CITY OF OXNARD
Environmental Impact Report

SCH #2000051046

1.0 INTRODUCTION

FIGURE 2-20

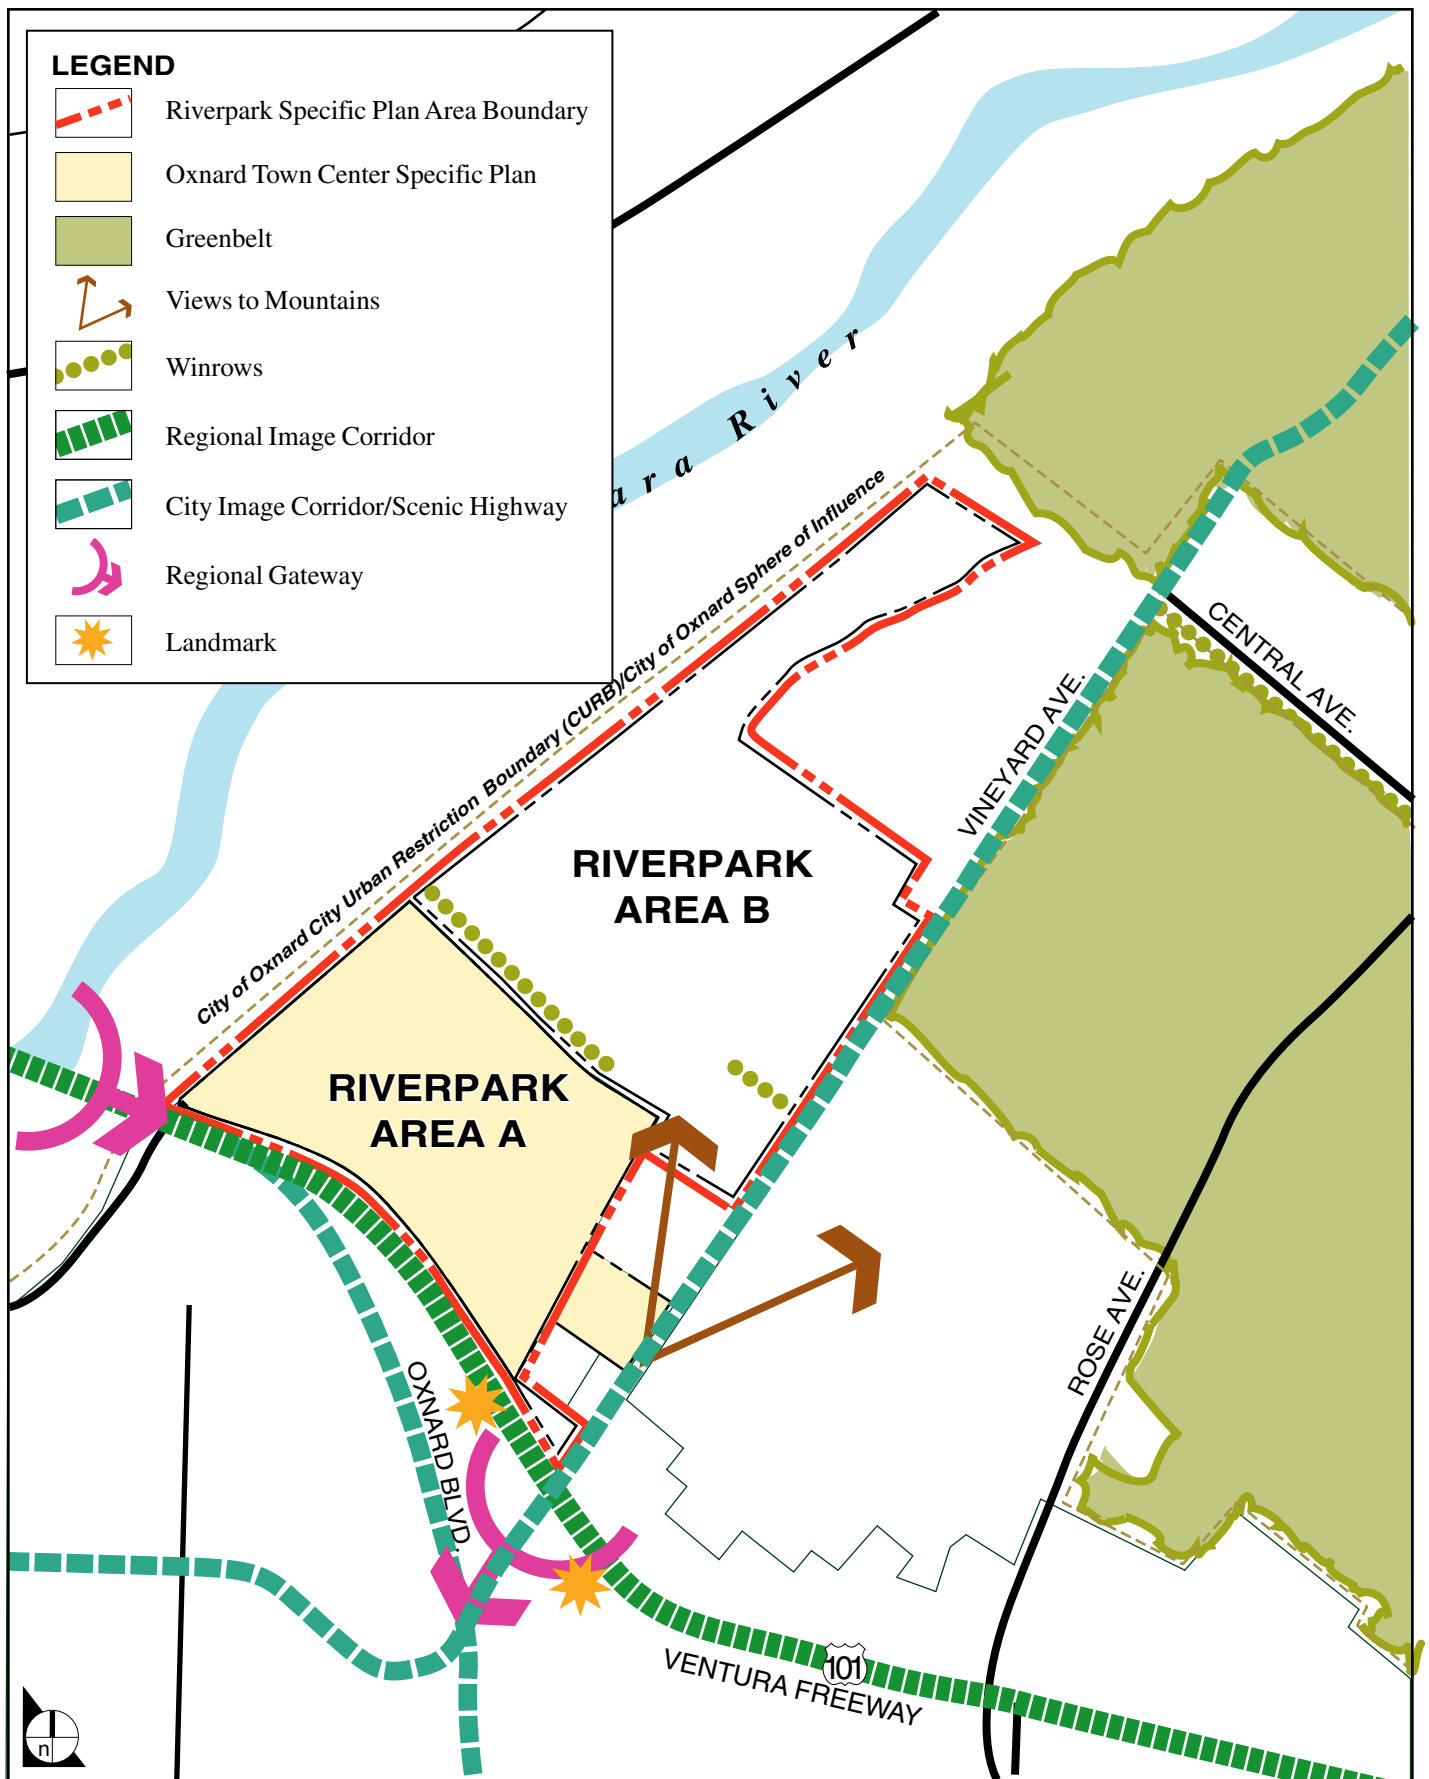
Figure 4.2-7. The use of the term "Greenbelt" in the legend may be confused with the Oxnard-Camarillo Greenbelt. The figure illustrates the Oxnard General Plan Community Design Structure Map, and indicates that the northern portion of RiverPark Area B is located within a "greenbelt". However, as noted on page 4.2-27, the Specific Plan area does not include any portion of the Oxnard-Camarillo Greenbelt. The boundary of the "greenbelt" shown on Figure 4.2-7 also is not consistent with the Oxnard-Camarillo Greenbelt boundary. If the "greenbelt" indicated on the General Plan Community Design Structure Map is intended to be different than the Oxnard-Camarillo Greenbelt, the legend on Figure 4.2-7 should be revised to indicate that they are not the same, to avoid confusion to decisionmakers and the public.

Figure 2-20 is a recreation of a portion of the 2020 Community Design figure contained in the Community Design Element of the Oxnard 2020 *General Plan*. This figure is citywide in scale and general. The text of the Community Design Element identifies the agricultural land in the Oxnard-Camarillo-Del Norte Greenbelt as a visual resource. The referenced figure has been revised to reflect the boundaries of this greenbelt. Please see the exhibit following this page. As mentioned in this comment, no portion of the proposed Specific Plan Area is located within the Oxnard-Camarillo-Del Norte Greenbelt.

The referenced exhibit has been revised as discussed above in the response to Comment VCAC-8. The text in page 4.2-27 is revised to read as follows:

FIGURE 2-21

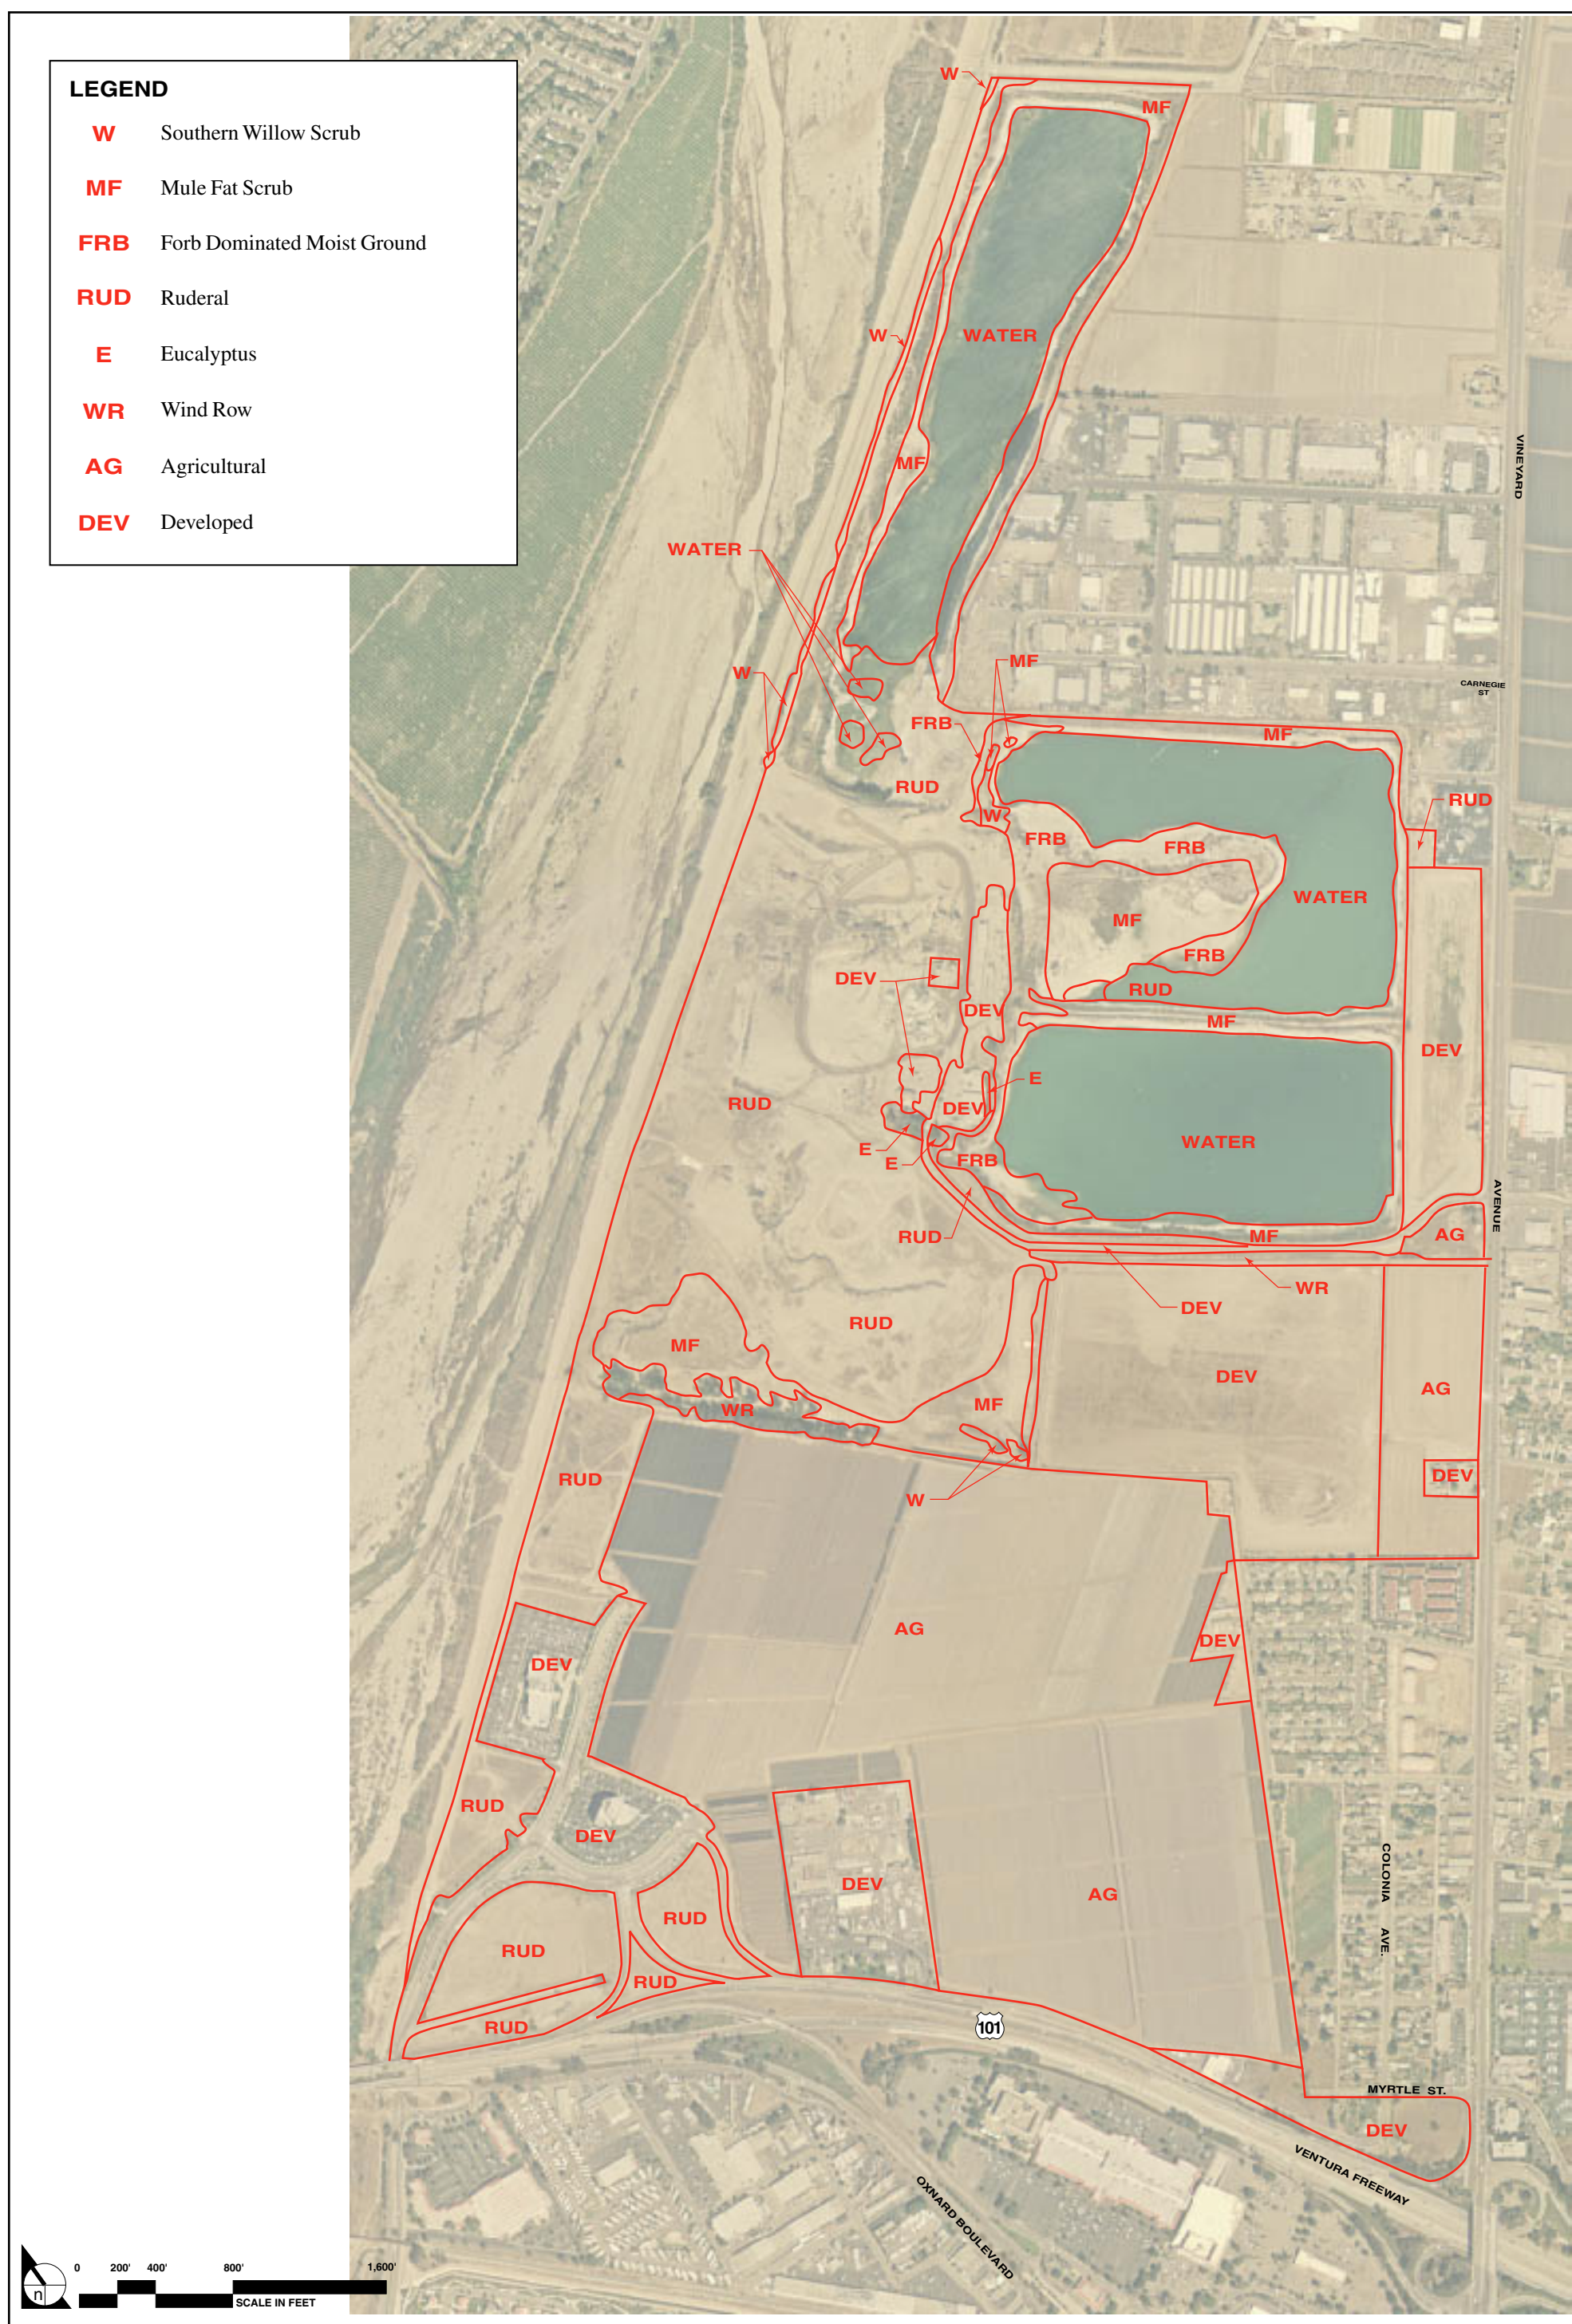
Page 4.4-4, last paragraph. The text states that at the time of field surveys for the Draft EIR, a portion of El Rio Retention Basin No. 2 was in agricultural production. Figure 4.4-1 indicates that El Rio Retention Basin No. 1 also was in production. The text should be revised accordingly.

El Rio Retention Basin No. 1 is not used for agricultural purposes and was not in production at the time of the referenced field surveys. Figure 4.4-1 has been revised and is presented on the following page as **Figure 2-21**.

FIGURE 2-23

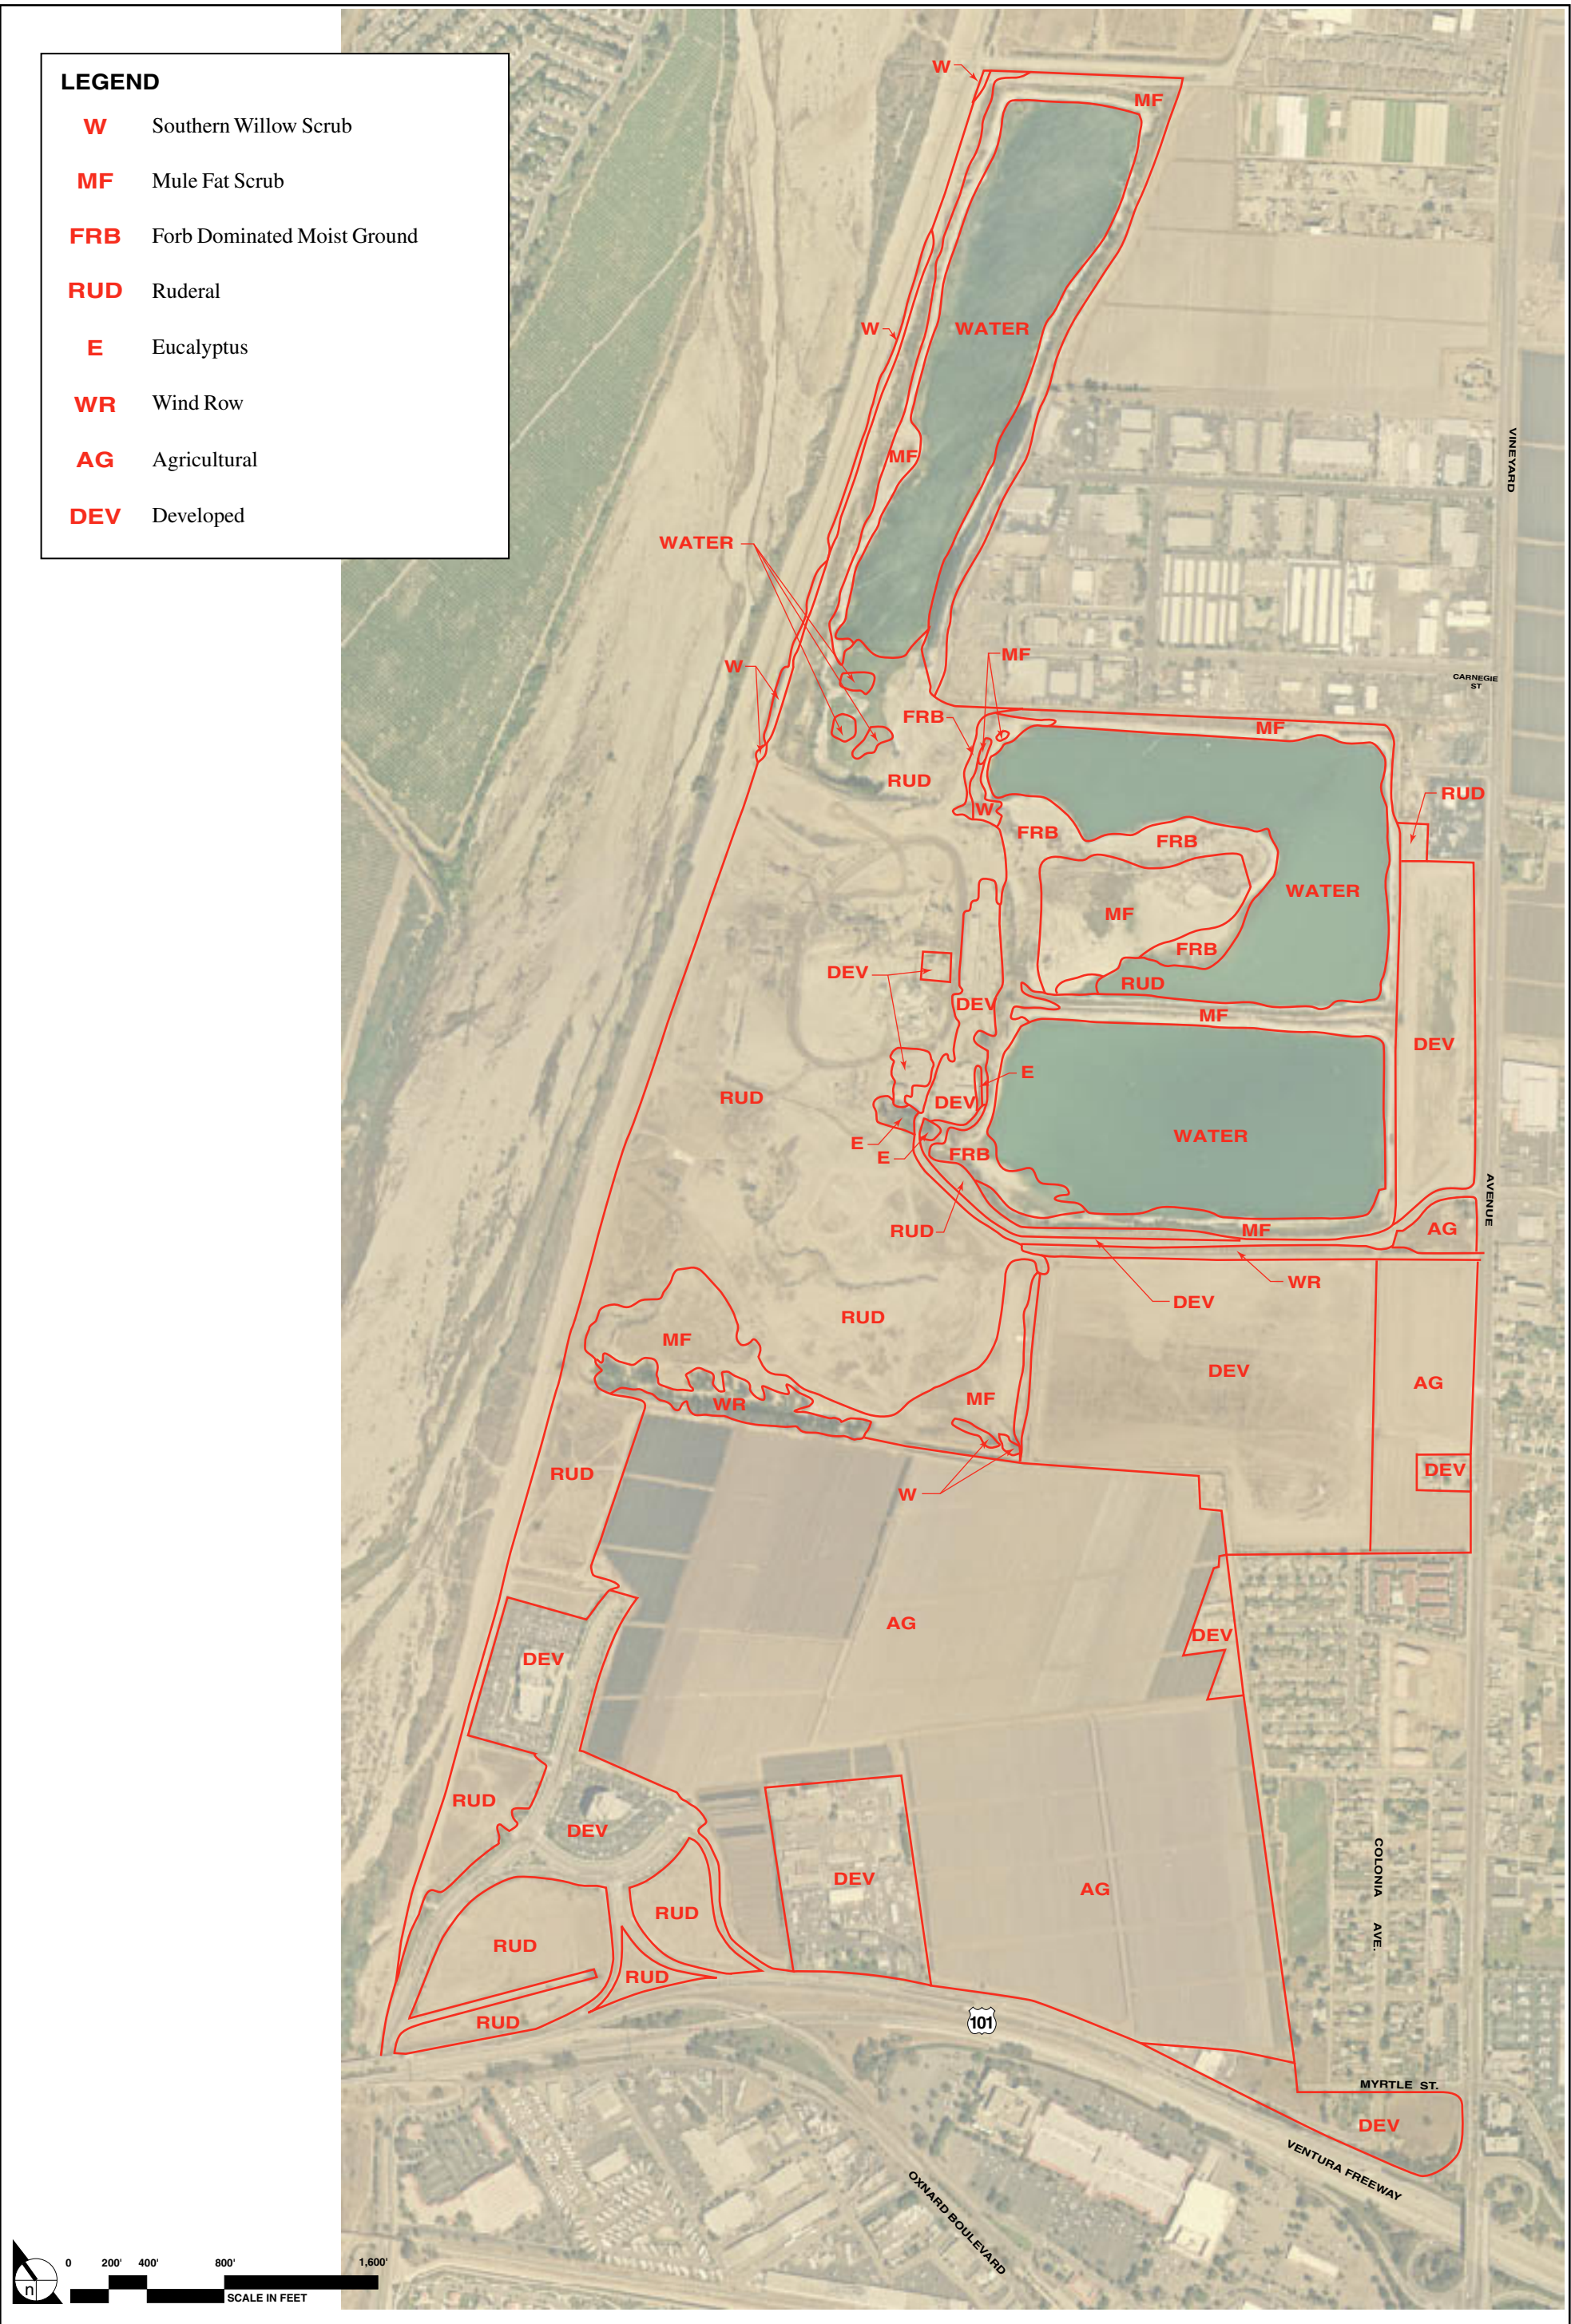
Page 4.6-10, bottom of page and -11, top of page. The text indicates that a strip of agricultural land located between Vineyard Avenue and El Rio Retention Basin No. 2 includes 16 acres located on the Retention Basin site and a small 3-acre parcel immediately north of this parcel. This statement is inconsistent with Figure 4.4-1, which illustrates that Retention Basin No. 2 is in agricultural production. Further, Figure 4.6-3 is inconsistent with Figure 4.4-1. Figure 4.6-3 shows that only the 19 acre strip adjacent to Vineyard Avenue is in agricultural production, and not Retention Basin Nos. 1 or 2. The figures and text should be revised to be consistent.

Please see **Figure 2-23** (following this page) which presents an aerial photograph of the portion of RiverPark Area ‘B’ still under agricultural production. As shown in **Figure 2-23**, the construction of the 15 foot deep El Rio Retention Basin No. 2 by the County of Ventura in 1997 impacted the agricultural land on this portion of the proposed Specific Plan Area. Presently only a small strip of agricultural land along Vineyard Avenue remains undisturbed and in agricultural production. This remnant strip of agricultural land is approximately 19 acres in size.
